**Subject: ITB #26136-B: Traffic Signal - Banks Rd & Ellis Rd Construction
Addendum #1**

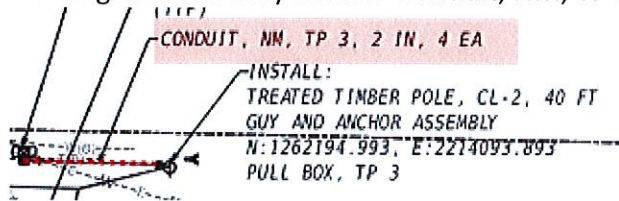
1. Could you please double check these two pay items quantities?
 - 682-9950 Directional Bore – 5 in 100 LF and
 - 682-6233 Conduit, Nonmetal, TP 3, 2 in 120 LF

Drawing 27-0003 only shows: Conduit, NM, TP 3, 2 IN, 4 EA. See below.

The quantity for Pay Item 682-6233, Conduit, Nonmetallic, TP 3, 2 IN (120 LF) represents the four (4) conduit runs between the proposed timber pole and the proposed signal cabinet located in the northeast quadrant of the intersection. The conduit is designated as Type 3 because the individual runs exceed 20 feet in length.

The quantity for Pay Item 682-9950, Directional Bore – 5 IN (100 LF) is associated with the installation of the electrical service crossing between the proposed power service point at the utility pole in the northwest quadrant and the proposed signal cabinet in the northeast quadrant. This directional bore is separate from the Type 3 conduit installation.

As noted in the plans, all materials, equipment, and work necessary to provide the power service connection shall be included in Pay Item 939-5010.
